Response to request for review

"Seguntor Bioenergy 11.5MW EFB Power Plant" project (0386)

THE SITE MAP OF KINA BIOPOWER BIOMASS POWER PLANT AND SEGUNTOR BIOENERGY BIOMASS POWER PLANT AT SANDAKAN SABAH MALAYSIA

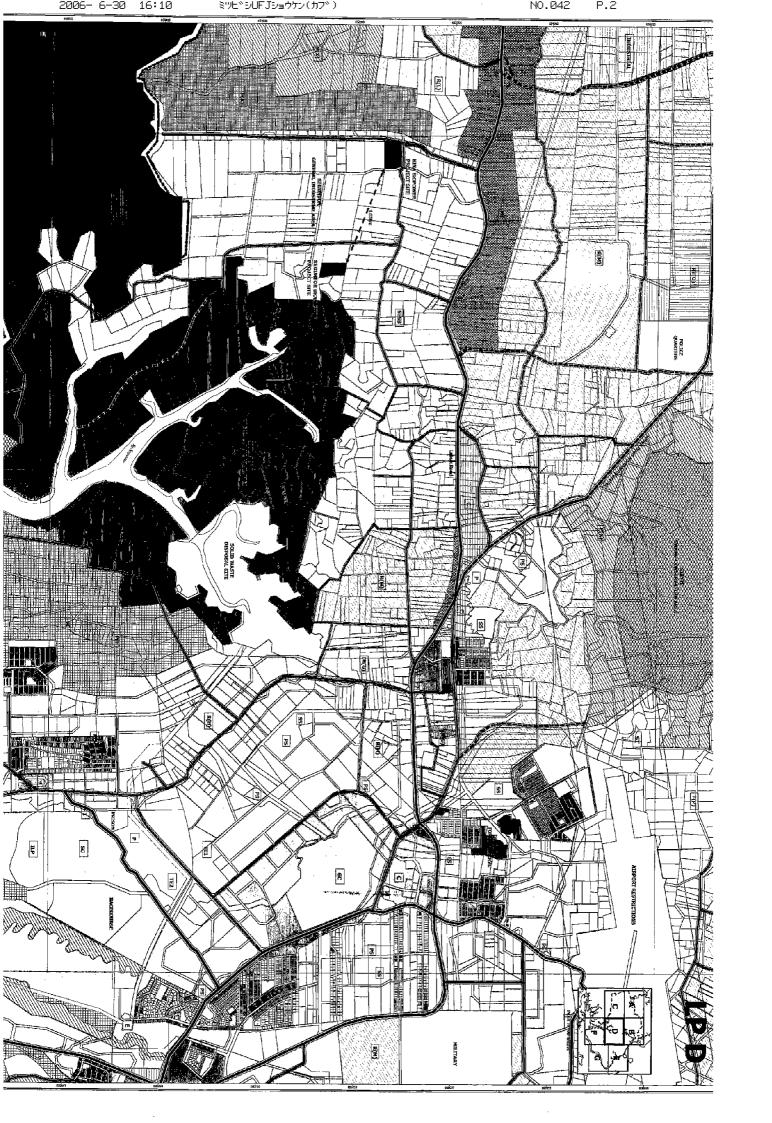
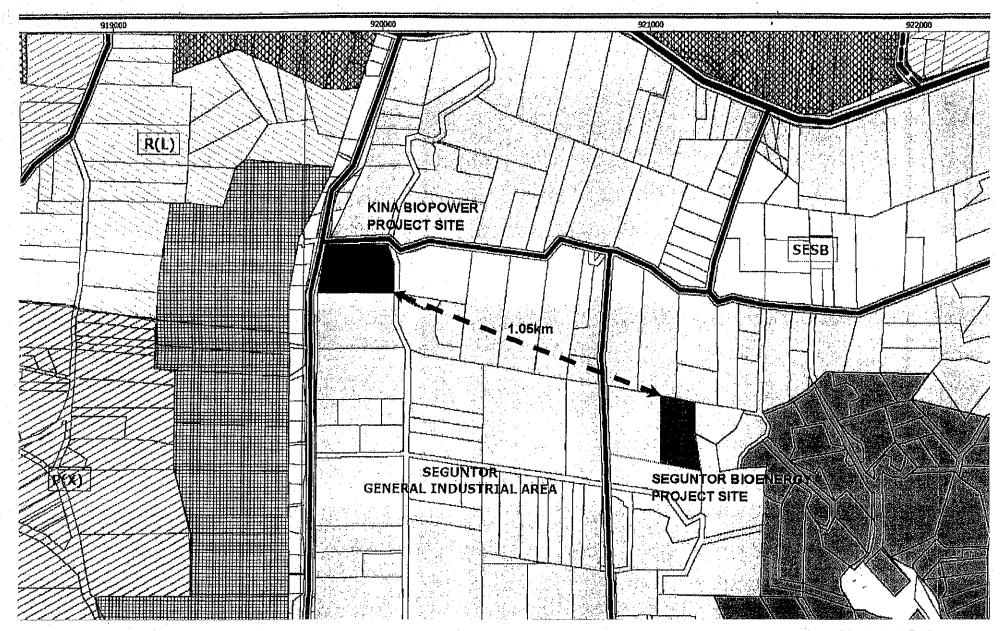
- 1) The Board members noted that the project should have applied version 08 of AMS-I.D and AMS-III.E, which came into effect on 3 March 2006, since the project was submitted for registration on 21 April 2006;
- 2) The Board member request that the validation report should have stated the exact distance between the "Seguntor Bioenergy 11.5MW EFB Power Plant" project and the adjacent "Kina Biopower 11.5MW EFB Power Plant" project in order to justify that the "Seguntor Bioenergy 11.5MW EFB Power Plant" project is not a debundled component of the "Kina Biopower 11.5MW EFB Power Plant" project.

- 2) As shown by the maps enclosed to this letter, the exact distance between the "Seguntor Bioenergy 11.5MW EFB Power Plant" project and the "Kina Biopower 11.5MW EFB Power Plant" project is 1.05 km. The project boundaries of the two projects are thus not within 1 km of each other at the closest point. The two projects are thus not a debundled component of each other in accordance with the Board's guidance for determining the occurrence of debundling. DNV verified that the distance between the two plants is at least 1 km by driving from one plant to another during the site visit.
